**VILLAGE OF DOWNERS GROVE**  
 Report to the Village  
 3/6/2018

<b>SUBJECT:</b>	<b>SUBMITTED BY:</b>
2001 63rd Street - Planned Unit Development Amendment, Special Use and Plat of Subdivision	Stan Popovich, AICP Director of Community Development

**VILLAGE OF DOWNERS GROVE  
REPORT FOR THE PLAN COMMISSION  
FEBRUARY 5, 2018 AGENDA**

<b>SUBJECT:</b>	<b>TYPE:</b>	<b>SUBMITTED BY:</b>
17-PLC-0041 2001 63 <sup>rd</sup> Street	PUD Amendment, Special Use and Plat of Subdivision	Rebecca Leitschuh, AICP Senior Planner

EAST ELEVATION

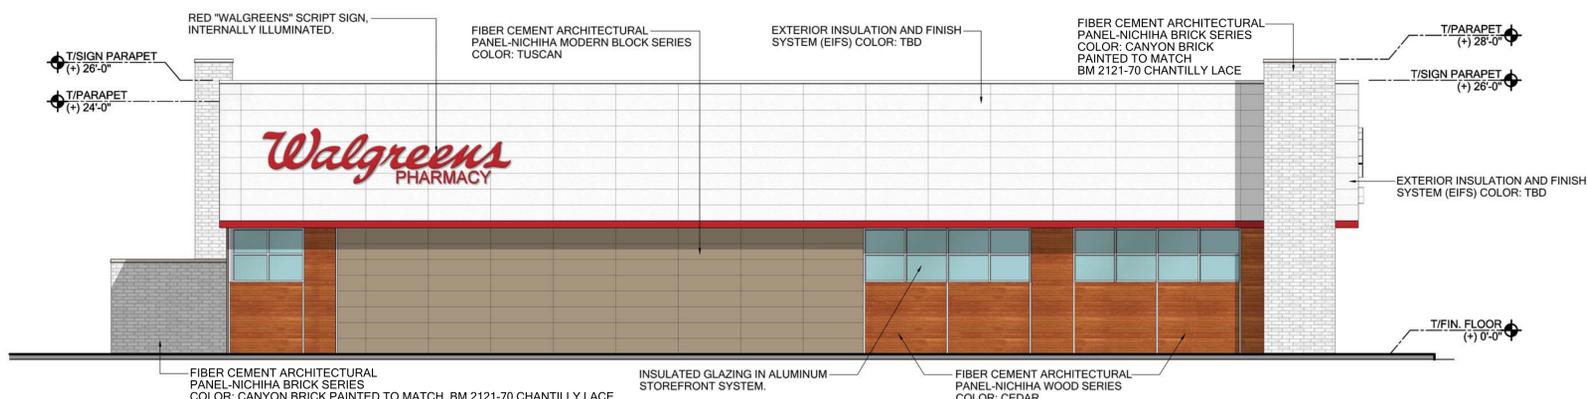
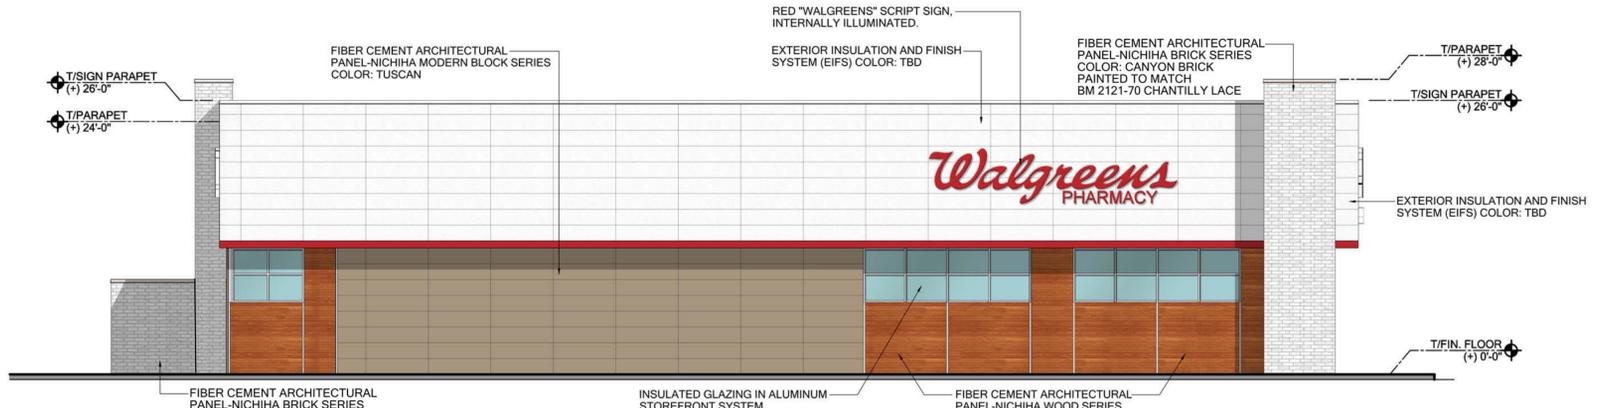
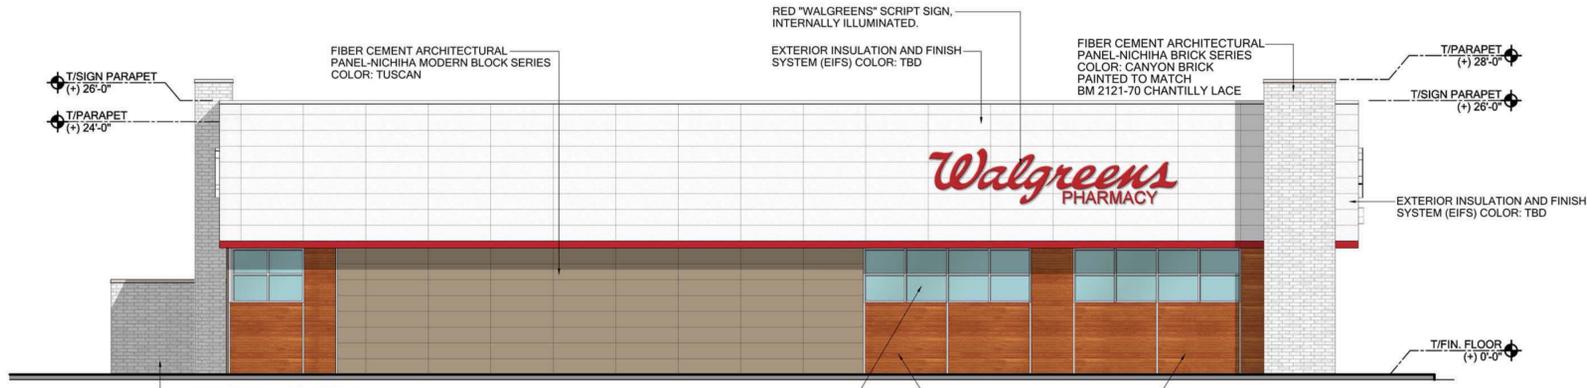
This item was discussed at the February 20, 2018 Village Council meeting. Based on Council direction, the petitioner has revised the east elevation so the left side of the elevation mimics the right side of the elevation. The new windows on the left side of the elevation will be opaque spandrel glass. The spandrel glass will appear as a window; however, you will not be able to see through the spandrel glass. The revised elevations are attached.

The Woodward Avenue (east) elevation continues to wrap the corner with wood panels, windows, and the white EIFS overhang. Staff requests a condition be made to extend the EIFS design element across the entire length of the eastern wall so as to bring greater design detail to the east elevation. A vertical pier, identical to the one on the western elevation, intersects the horizontal planes. The dumpster enclosure, while in a street yard, is designed to complement the building, incorporating the same fiber cement panel system.

Revised east elevation

Revised elevation dated February 23, 2018
